AIRCRAFT ENGINES

SERVICE INSTRUCTION

REPLACEMENT OF THE CIRCLIP IN THE SPRAG CLUTCH HOUSING ON ROTAX® ENGINE TYPE 912 AND 914 (SERIES)

SI-912-006 R1

Fig. 1

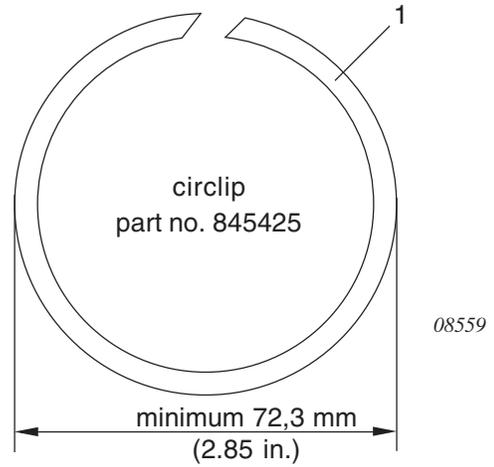
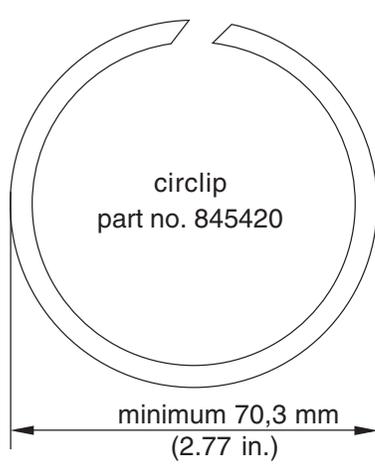
- At exchange take care of the following:
As the new circlip is slightly bigger as the one fitted previously, the end gap on the new circlip is smaller.
- all used parts and spare parts are unserviceable and must be scrapped.

On repair work on sprag clutch (2) or at engine overhaul the circlip 68 part no. 845420 has to be replaced by the circlip 70 (1) part no. 845425. Verify by inspection if the new circlip 70 is already fitted. See fig. 1

The measurement of the circlip takes place in developed condition!

Fig. 2

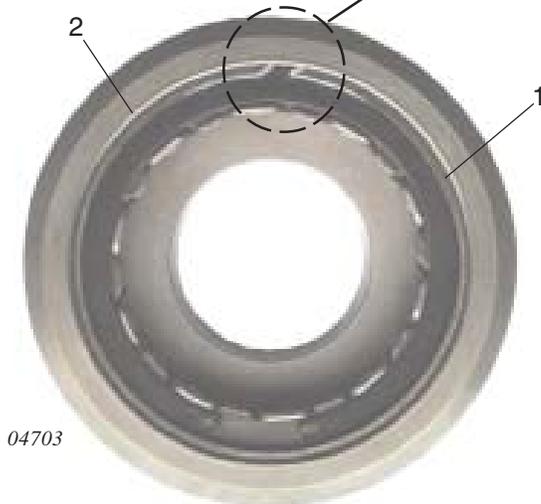
■ **CAUTION:** Make sure that the new circlip will be fitted as depicted in fig. 2 Detail A. To warrant a tight fit pay attention to correct position of the circlip ends (3).

DETAIL A: shows the correct position of the circlip

DETAIL B: shows the incorrect position of the circlip
